STAFF RECOMMENDATION
1613 Eastland Avenue
January 21, 2015

Application: New construction – detached accessory dwelling unit
District: Eastwood Neighborhood Conservation Zoning Overlay
Council District: 06
Map and Parcel Number: 08306022800
Applicant: Kody Holt, Middle TN Garage & Barn
Project Lead: Sean Alexander, sean.alexander@nashville.gov

2nd Floor Plan

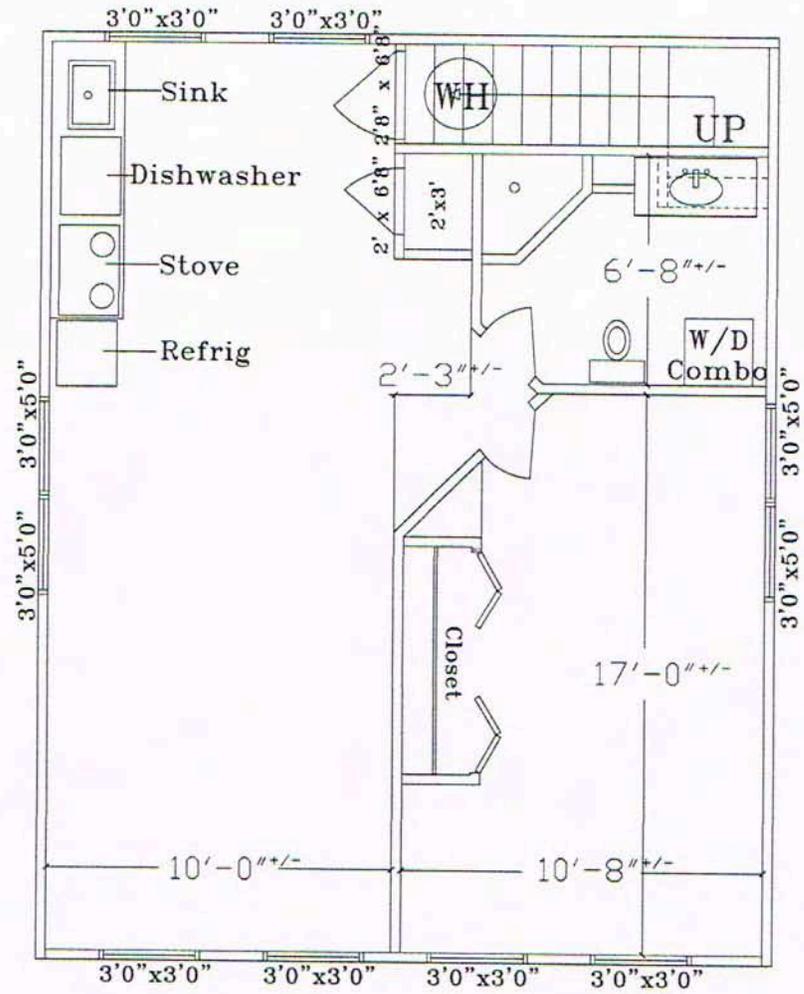
Dormers: The dormers on the proposed outbuilding are proposed to be ninety-percent (90%) of the width of the roof, which is greater than the fifty-percent (50%) allowed by the design guidelines and the standards of the ordinance. Additionally, the dormers would not sit back from the first story wall by two feet (2’) as is required by the design guidelines and the standards of the ordinance.

- The building be designed to meet the requirements of the ordinance which state that the dormers should be no greater than fifty percent (50%) of the width of the roof plane and sit back from the wall below by at least two feet (2’); and
- The windows and doors are approved by Staff prior to purchase and installation.
